SERVICE BULLETIN

Super Raven Dash-M Series

TITLE: LINE ATTACHMENT STRUCTURAL ENHANCEMENT

Image 1

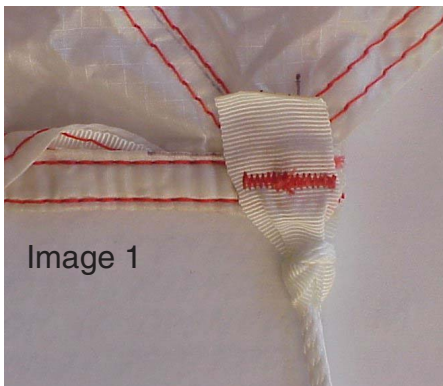
Affected canopies have serial numbers whose last 5 digits are below 35937 and can be further identified by the single 42 stitch bartack in the .75" T-III MIL-T-5038 tape line attachment loops (Image 1).

The seam where the Lower Surfaces join are sewn with a single pass using a double needle machine. The original line attachment loop is secured with a single bartack between the stitch rows of the double needle seam that joins the lower surfaces (Image 1). You will notice that the leading edge of the canopy already has a 28 stitch tack on the loadbearing stitchrow beneath the line loop (Image 3). You will be placing your new bartack right over the top of the existing tack, except that you will be sewing through the Type III loop material as well.

Image 4

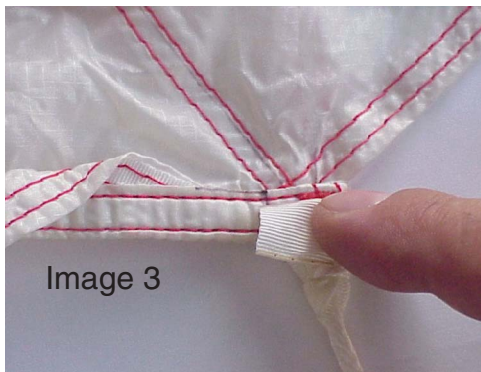
Image 4: Compliance with this Service Bulletin requires adding a 42 stitch bartack in 16 places, one at each of the eight 'A' line loops and one at each of the eight 'B' line loops.

Place the additional bartack precisely on the loadbearing stitch row of the double needle seam (Image 4), above the existing line attachment bartack that is already between the stitch rows. Be very careful that the underside of the T-III loop tape does not curl under on the blind side of the setup. The additional bartack must be centered evenly within the .75 inch T-III loop material.
